## Memorandum of Advice

**Heritage Advice:** Heritage Implications of Yarra Planning Scheme Amendments C218 and C219

**Prepared for:** Evan Burman, Strategic Planner, City of Yarra

**Date:** 25 January 2018

Figure 7. Framework Plan - Panel recommended version

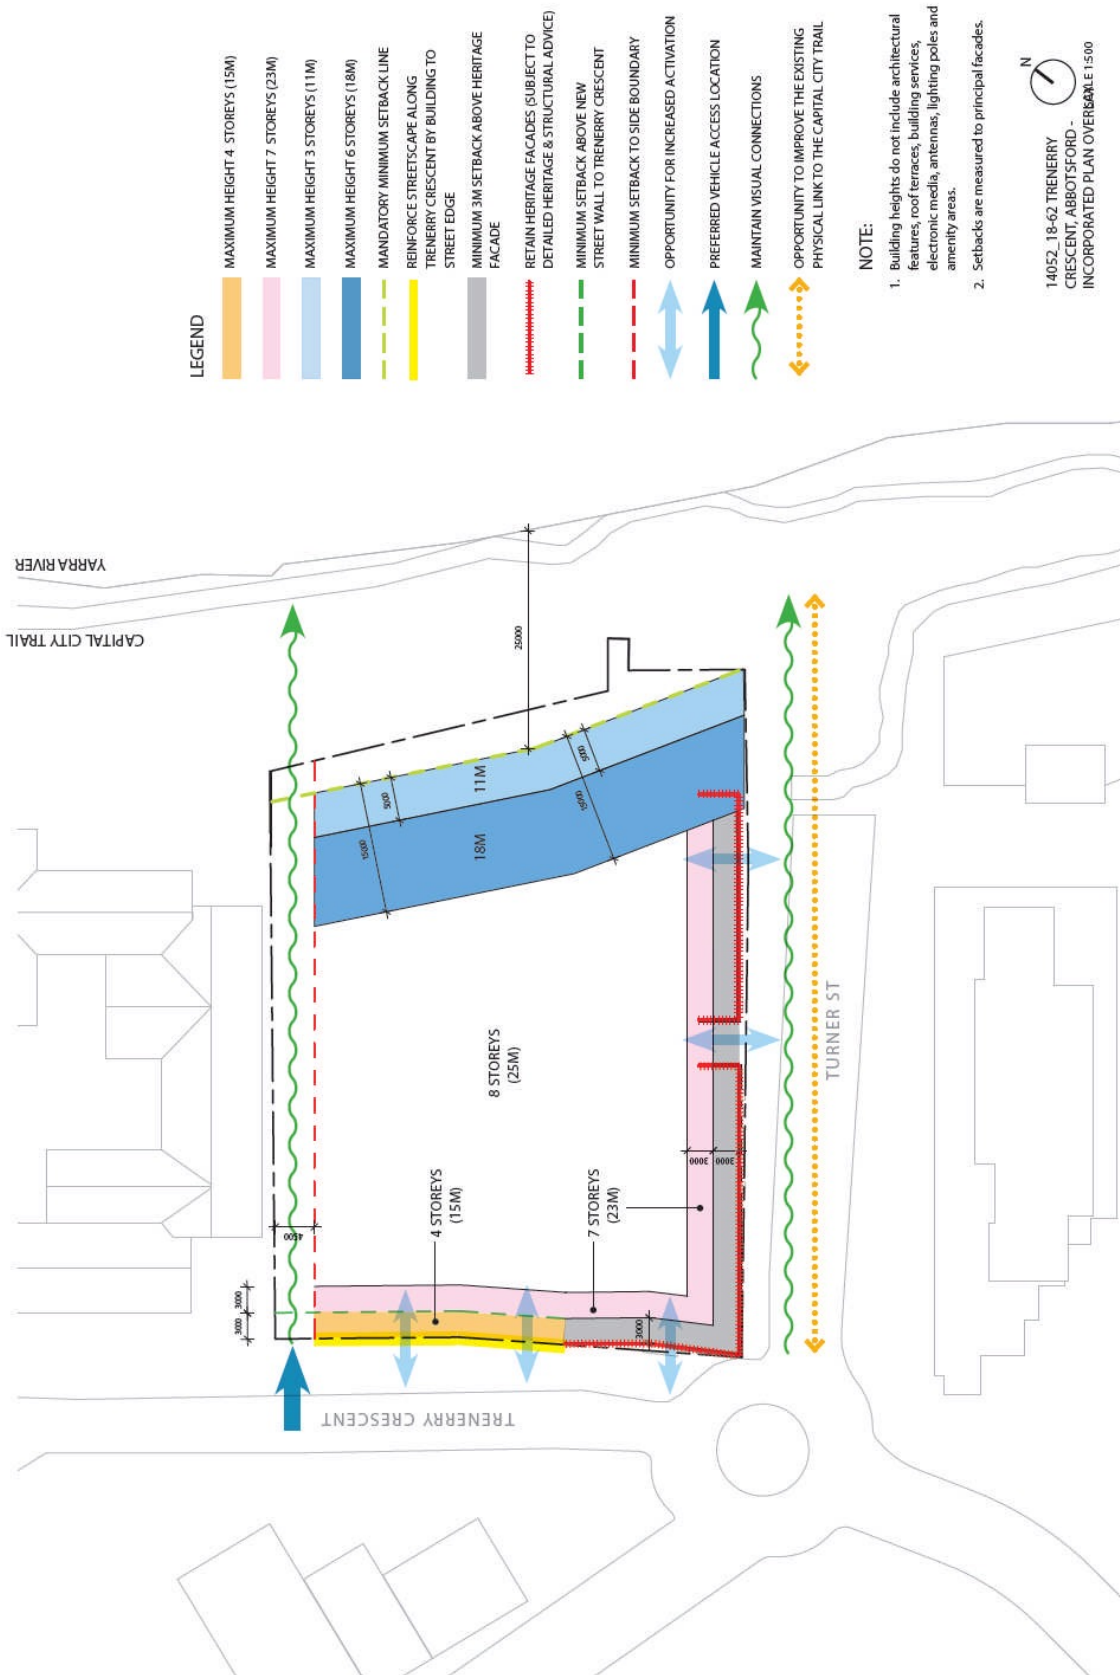
Panel's recommended Framework Plan complies with the setbacks identified in DDO1, however we note that the Panel version states that building heights within the Area Boundary for DDO1 – Area C are preferred maximum heights, contradicting DDO1 which states that these are mandatory maximum heights. This inconsistency should be corrected prior to adoption and approval of the amendment to avoid contradictory controls.

The Panel-recommended plan increases the amount of fabric of the Trenerry Crescent façade required to be retained by requiring that "...so much of the return on Trenerry Crescent and Turner Street as necessary to support the retained wall."<sup>3</sup> However, we note that with modern construction techniques for retaining facades this means that the return depth may be no more than the thickness of the masonry wall itself.

Other changes made to the exhibited Framework Plan recommended by Panel will, in our view, have a detrimental impact of the cultural heritage significance of both 18-62 Trenerry Crescent and the contribution it makes to the Victoria Park Precinct (HO337). These impacts include:

- Removal of the requirement to retain the Turner Street façade of the 1920s building
- Reduced requirement to retain return walls of both the 1911 and 1920s buildings on Turner Street
- Reduced setback behind the retained façade of the 1911 building from 3m to a height of 23m and a further 3m to the height to 25m, to 2m.

These changes are contrary to the heritage provisions of the Yarra Planning Scheme as they allow the complete demolition of all the heritage fabric that has been identified as being of contributory significance (that is the 1920s structures and the 1984 additions and alterations) in Panel's recommended Statement of Significance.

In relation to new built form, the reduction in the setback behind the retained façade of the 1911 building from 3m to 2m further increases the likelihood that the new development will not be visually recessive and will dominate the heritage place.

Figure 8. Framework Plan - Council preferred plan for adoption

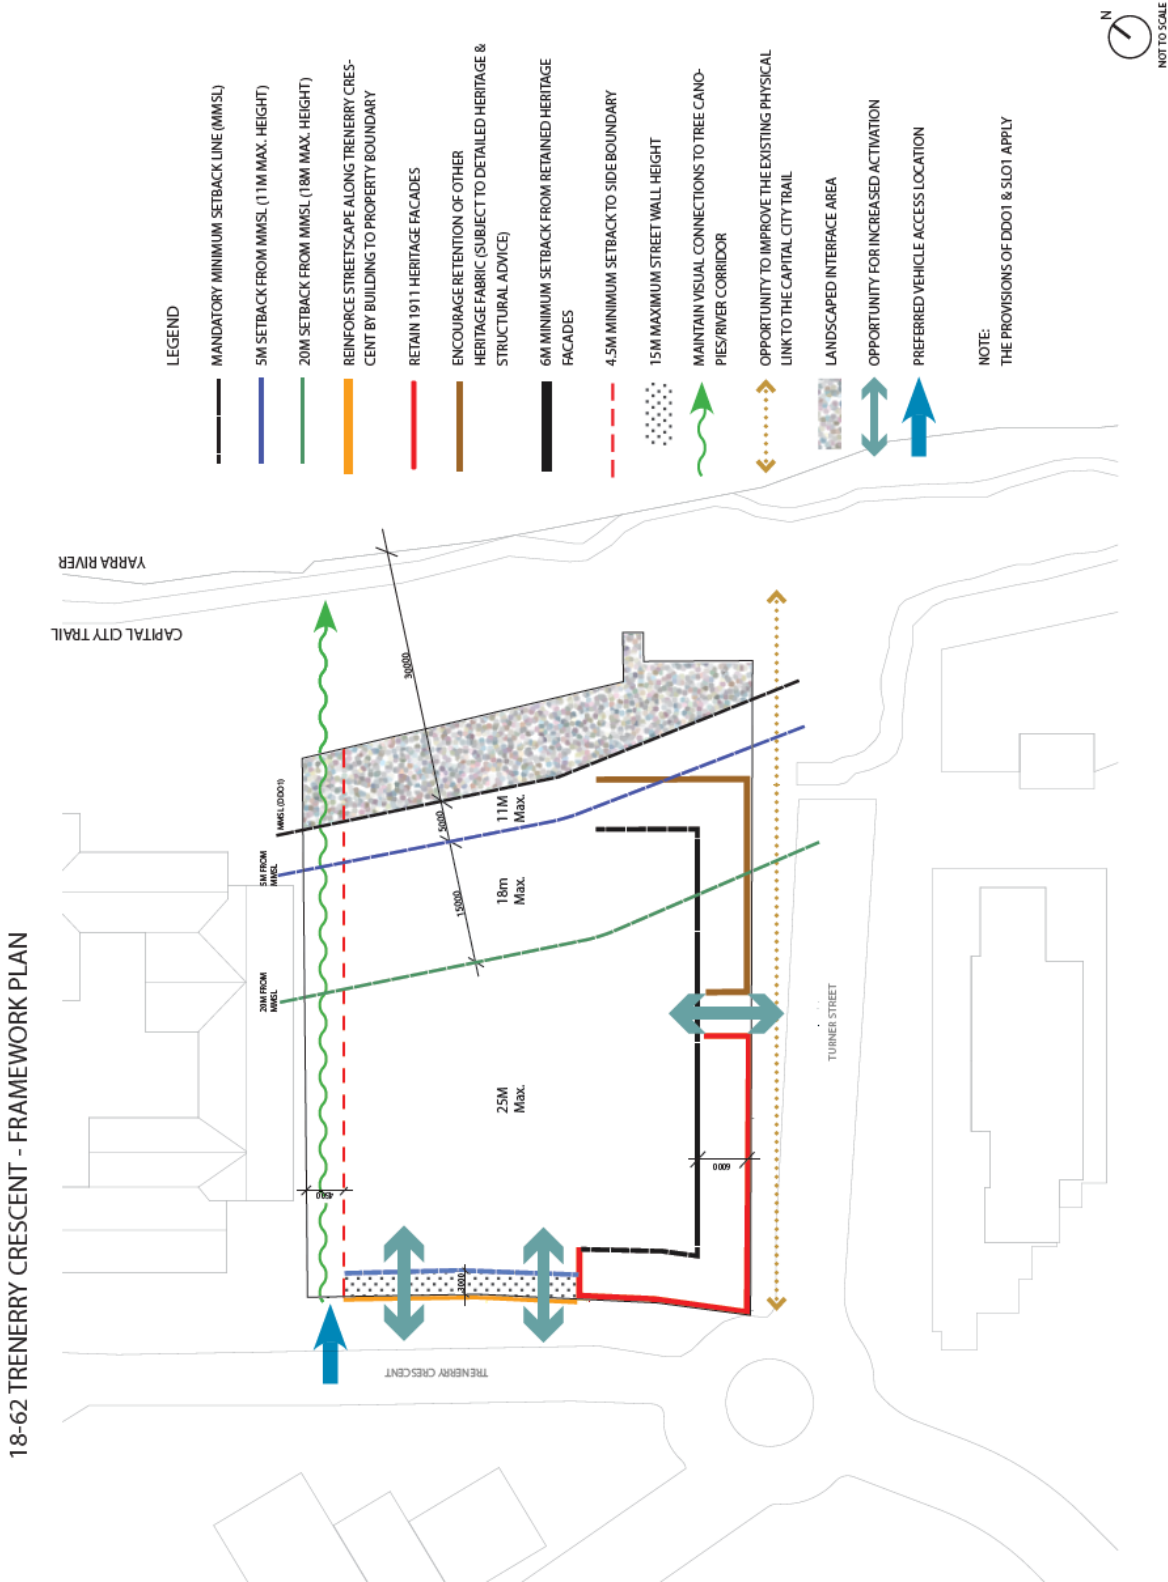
In response to the Panel Report, Council has prepared an amended Framework Plan (Figure 8). This document reflects the increased setbacks from the Yarra River recommended by Panel and retains the heritage elevations of the 1911 building facing both Trenerry Crescent and Turner Street, including return elevations on both streets.

Council's preferred Framework Plan also encourages the retention of the Turner Street elevation and the returns of this building, including the Daryl Jackson adaptation to the end of this building facing the Yarra River (Figure 10). In addition, the Council-preferred Framework Plan draws on Mr Gardner's evidence that a minimum 6m setback from the retain heritage fabric is necessary to retain the cultural heritage significance of the place (Figure 9).

It is our view that the Council-preferred Framework Plan should not just ‘Encourage Retention of Other Heritage Fabric’ on Turner Street but require that this fabric be retained. The loss of this fabric will remove any record of the history of development on this site beyond its original 1911 form and would result in the complete removal of all fabric that is identified as ‘contributory’ in the Panel-recommended version of the Heritage Citation for the place. Council’s preferred plan allows for the demolition of much fabric of primary and contributory significance, and it is therefore our view that it is reasonable to require that future development retain the Turner Street facades and the return wall facing the Yarra River (including the 1920s and 1984 works) in order to conserve a physical record of the historic development of the site.

We recommend that Council's preferred plan remove the qualifying statement in relation to retained heritage fabric being "Subject to detailed heritage and structural advice". The heritage structures are in good condition and there is no apparent reason why they should not be retained as part of any redevelopment. The onus should be on the developer to undertake any structural work necessary to retain the relatively small amount of fabric that the Framework Plan requires.

The wording of the 6m minimum setback could also be amended as it is currently unclear if the setback should be applied if the heritage façade of the 1920s building is demolished.

1. Amend the Heritage Citation and Statement of Significance for 20-60 Trenerry Crescent to include the recommended changes in Appendix 1.
2. Amend the legend in the Framework Plan from 'encourage retention' to 'retain' the 1920s structure facing Turner Street and the Yarra River.
3. Amend the Framework Plan to encourage the retention of 1984 elements, including the linking element between the 1911 and 1920s buildings on Turner Street.
4. Clarify if a 6m minimum setback from Turner Street and the Yarra River frontage is required if the heritage facades are not being retained.
5. Remove the qualifying statement in the legend that states heritage fabric is to be retained "Subject to detailed heritage and structural advice".

**Figure 12. Indicative Framework Plan – as exhibited**

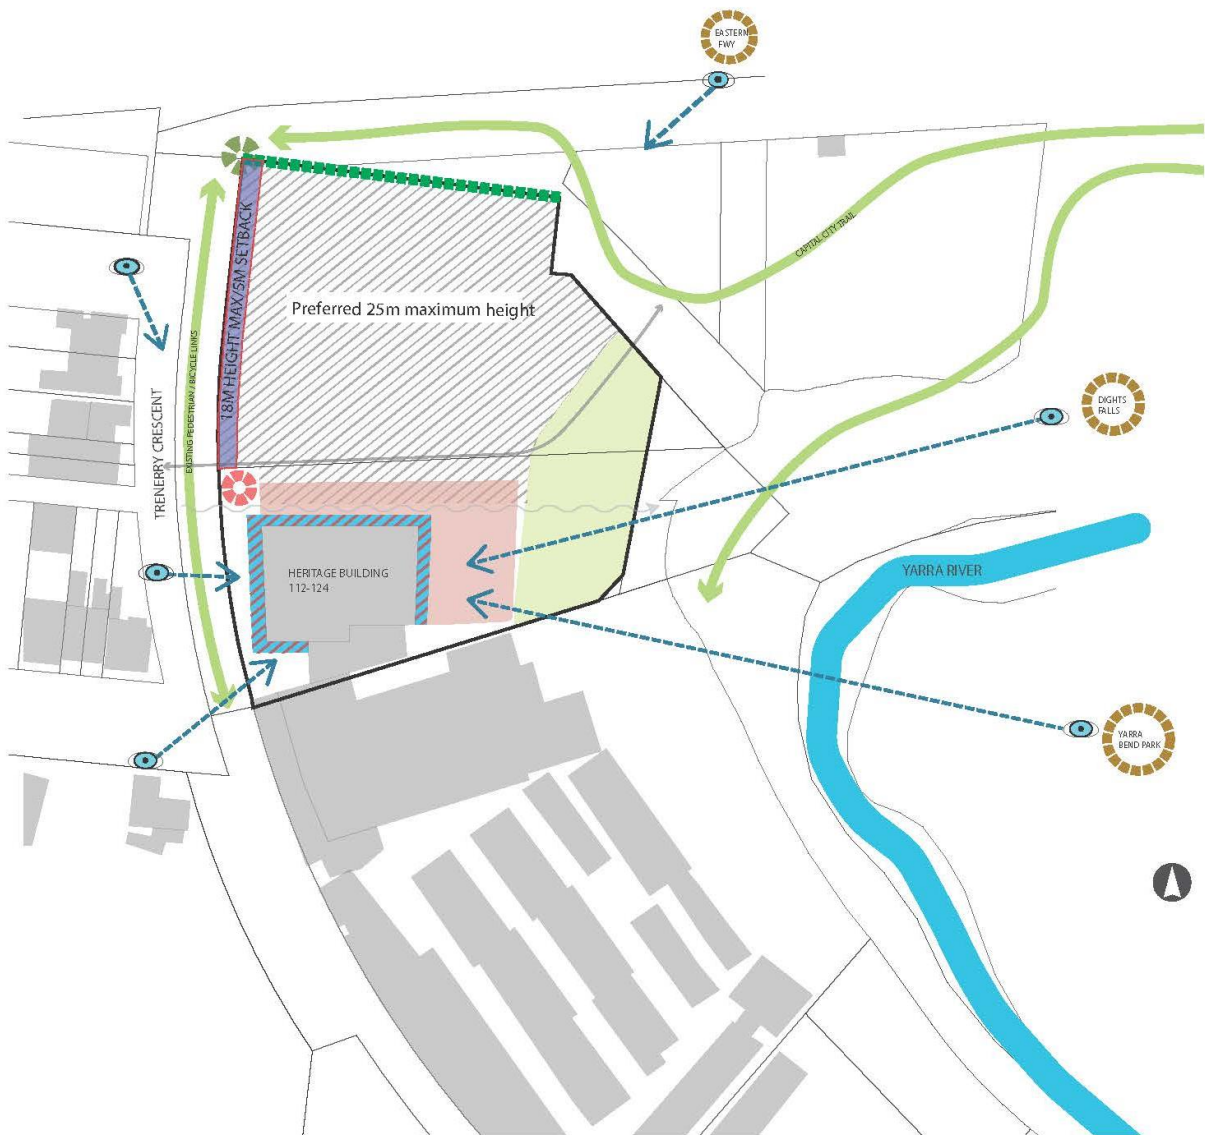
Detailed commentary on the exhibited Indicative Framework Plan was provided in expert evidence and is discussed in the Panel Report. It is not repeated in this memorandum.

Figure 14. Indicative Framework Plan – Council’s preferred plan

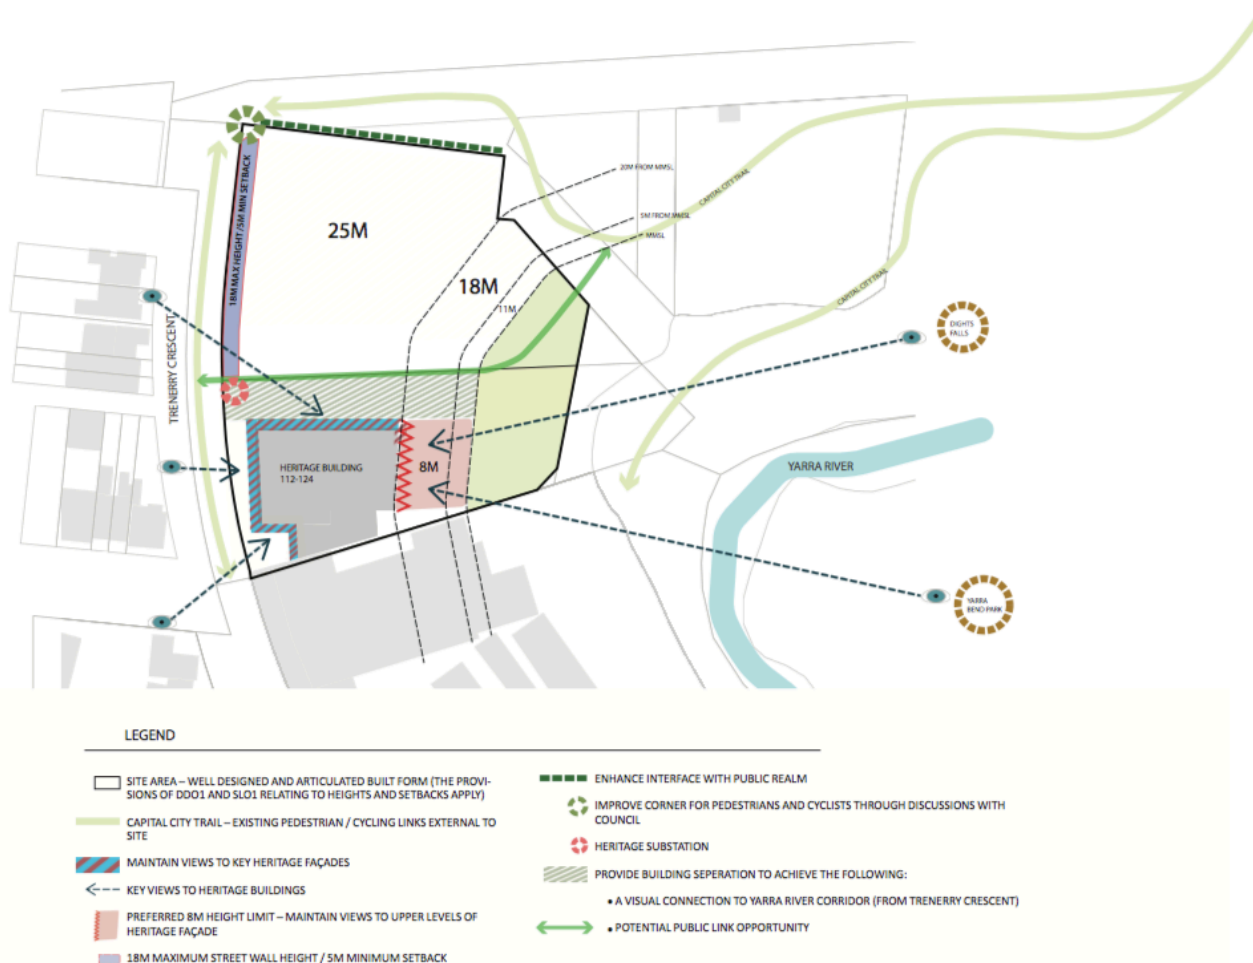
In response to the Panel Report, Council officers have prepared an amended Indicative Framework Plan (Figure 14) which ensures consistency with DDO1. It also removes the key view from the north side of Trenerry Crescent, opposite the Dights Falls Reserve car park, which we consider reasonable as this is not a key public realm location from which the public are likely to view the heritage building.

We note that the Council-preferred Indicative Framework Plan retains a building separation which, although less than the minimum 20m noted in the exhibited amendment, will achieve a satisfactory heritage outcome that allows views of the north façade of the heritage building to be maintained, provides a visual connection to the Yarra River, and allows a potential public access way through the site. In evidence, Mr Gard’ner and Mr Trethowan disagreed that a public (bicycle) link next to the northern façade of the heritage building would have an adverse impact on the heritage significance of the building. It remains our view that a physical separation between the heritage building and any new development can serve as a public link without any adverse impact on the heritage values of the place.

Further, we recommend that a minimum separation distance be annotated on the Indicative Framework Plan. A new building constructed to the edge of the northern wall of the sub-station would provide a separation of

approx. 15m, and this would appear to provide a satisfactory heritage outcome that protects key views of the northern façade of the former Austral Silk and Cotton Mills Factory/Warehouse.

1. Include a minimum dimension for the separation between the northern façade of the former Austral Silk and Cotton Mills Factory/Warehouse and any new development to the north.
